March 23, 2010

RE: Comments on ENERGY STAR for Set-Top Box (STB) Draft 1 Version 3.0 Specification

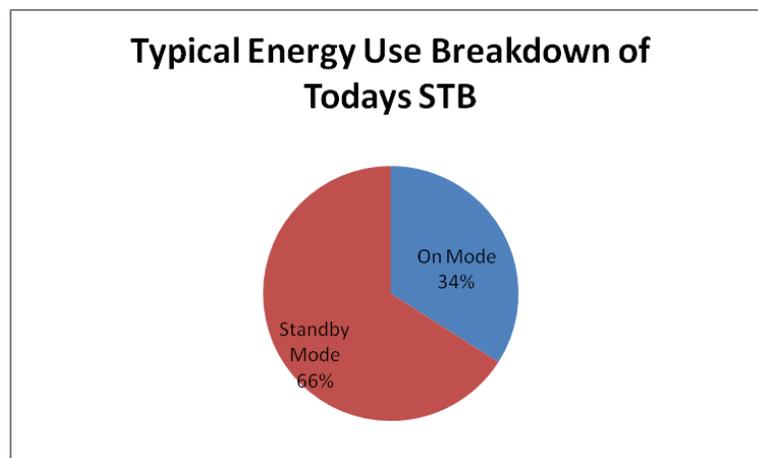
To better describe this opportunity, take a common occurrence today whereby the difference between on mode and Sleep power is only 5W (On mode is 25W, Sleep mode is 20W and the user watches/records 7 hours of TV per day). In this case, the STB consumes 64 kWh/yr when in active use and 124 kWh/yr when the user is not using the STB. We need to move beyond the current paradigm where STBs frequently consume roughly two-thirds of their annual energy use (see graphic below) when they are NOT in use and look to ENERGY STAR to help drive this transformation.
